FINAL PLAT
BROCK THIRD ADDITION
TO
WICHITA
SEDGWICK COUNTY, KANSAS

Re: S/D 97-22 - BROCK 3RD ADDITION (Final Plat)

STAFF REPORT
(Final Plat, Approved 4/3/97)

CASE NUMBER: S/D 97-22 - BROCK 3RD ADDITION

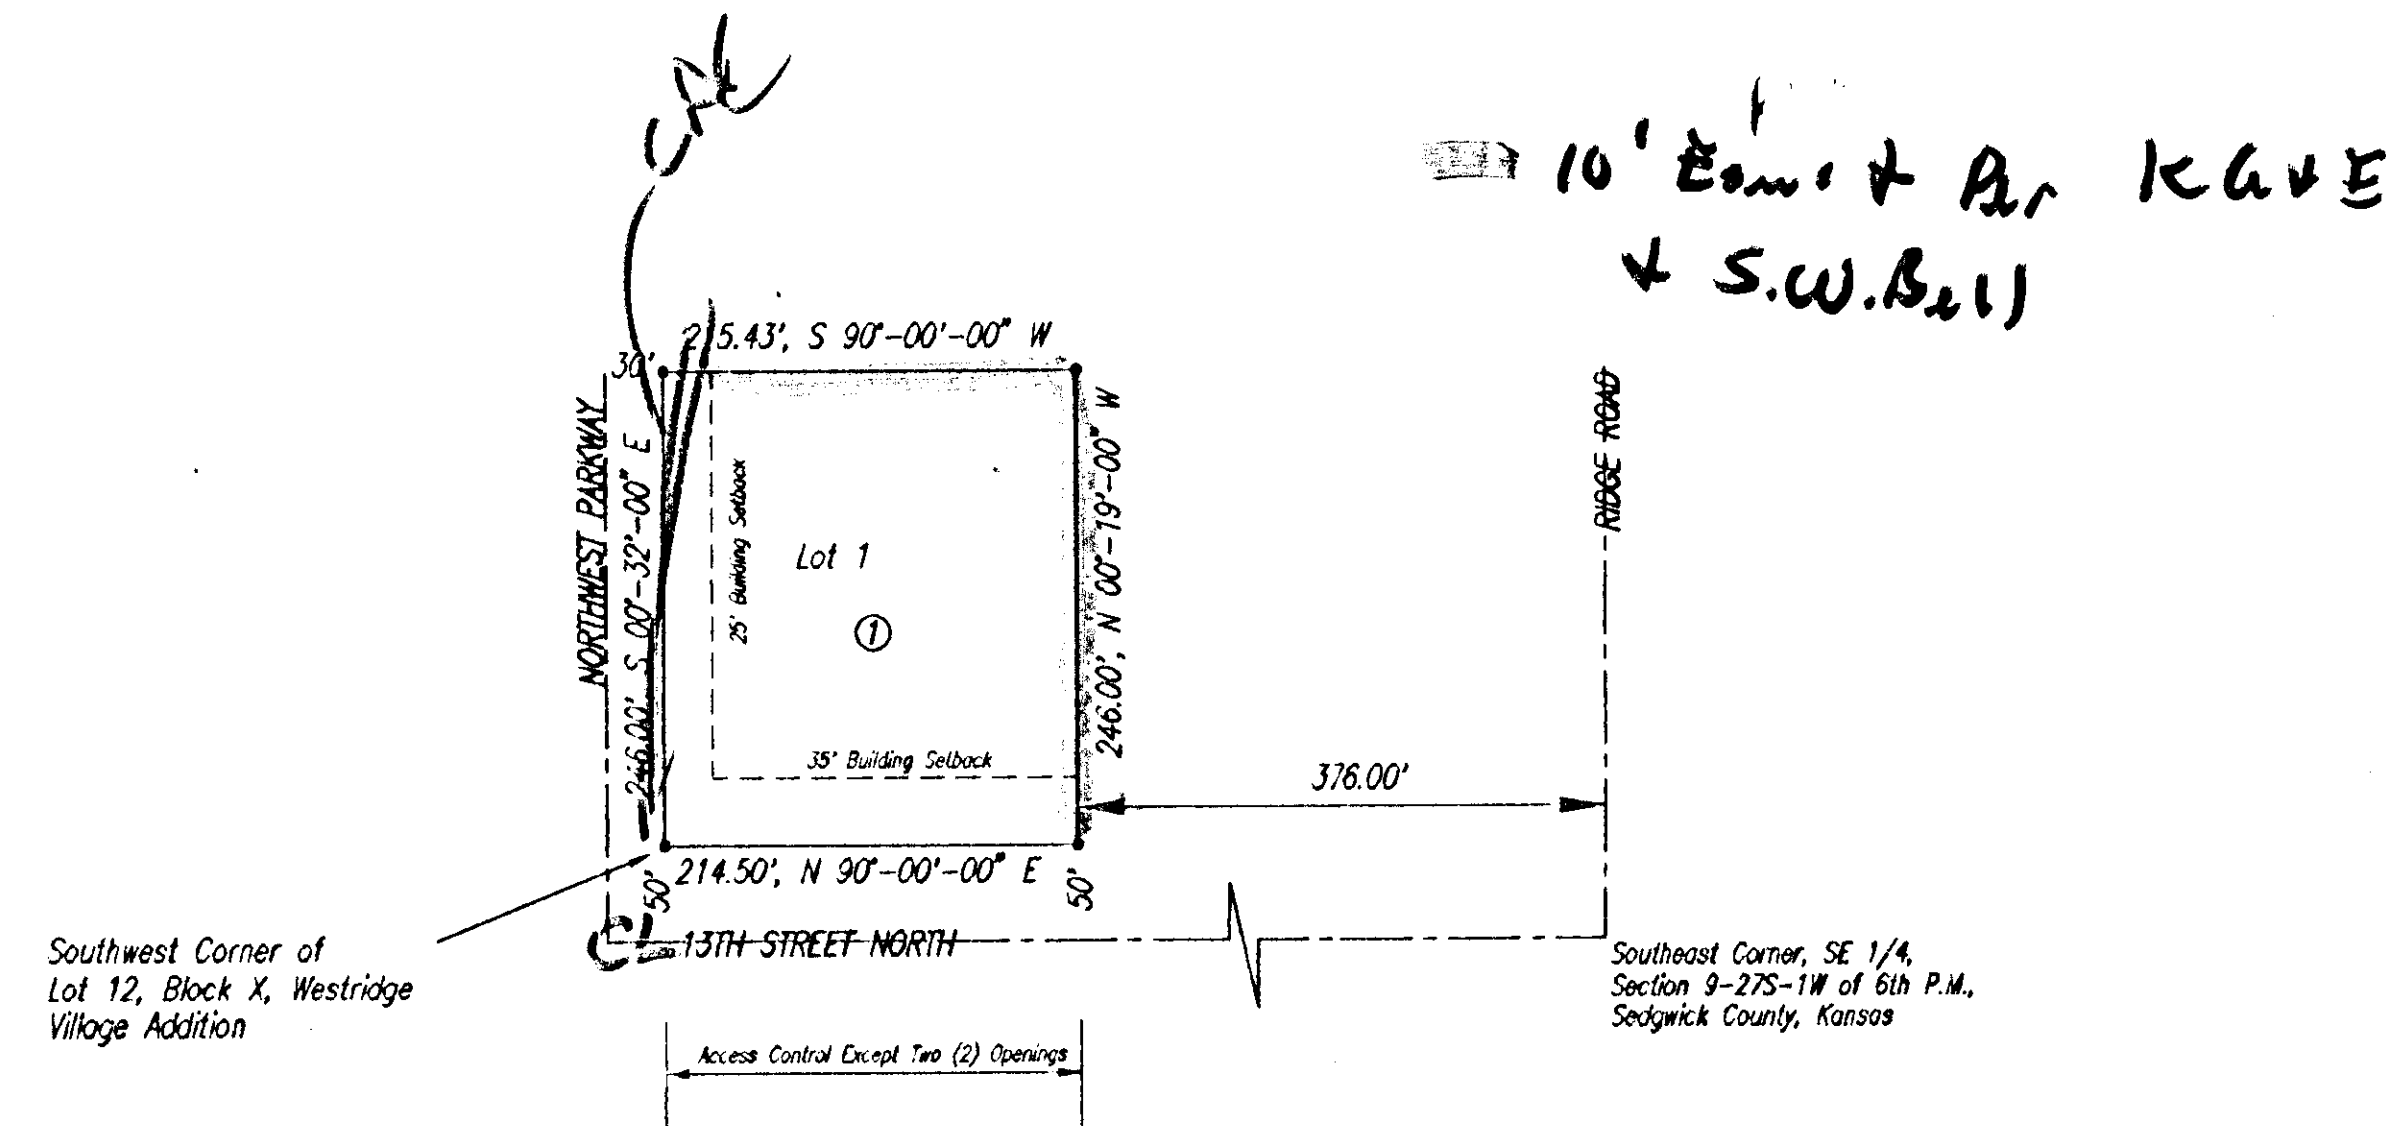
- A. The applicant shall submit a cross lot access agreement for the benefit of the Brock Second Addition, which allows that property to have access to and from 13th Street North by way of any allowed openings provided in the Brock Third Addition.

- B. The applicant shall guarantee any drainage improvements required by the platting of this property. Such improvements (private storm sewer) may be done at the time of site development.

- C. On the final plat tracing, complete access control shall be indicated to Northwest Parkway on the face of the plat. The plat's text shall also be amended to note this dedication, but also shall be revised to use the standard terminology for the dedication of access controls to the City and the approval of opening locations (13th Street) by the City Engineer.

- D. On the final plat tracing, the owner's signature and title (if any) shall be printed below the plat's signature line. If this ownership is different than now being shown by the platting binder, an updated binder shall also be provided with the final plat tracing.

- E. On the final plat tracing, the Deputy Register of Deeds shall be indicated as Michael D. Hurtt.
- F. If the dot symbols at the corner of this plat (lot) involve irons found, set, etc. this should be noted in a legend located below the north arrow.

- G. On the final plat tracing, the center line of 13th Street North shall be labelled "CL".
- H. The applicant shall install or guarantee the installation of all utilities and facilities which are applicable and described in Article 8 of the MAPC Subdivision Regulations. (Water service and fire hydrants required by Article 8 for fire protection shall be as per the direction and approval of the Chief of the Fire Department.)

- K. Perimeter closure computations shall be submitted with the final plat tracing. Section 5-101(c).
- L. Recording of the plat within thirty (30) days after approval by the City Council and/or County Commission.

- M. The final plat shall indicate the utility easements requested by K.G.& E. and Southwestern Bell which are indicated on the enclosed "marked" copy of the plat.
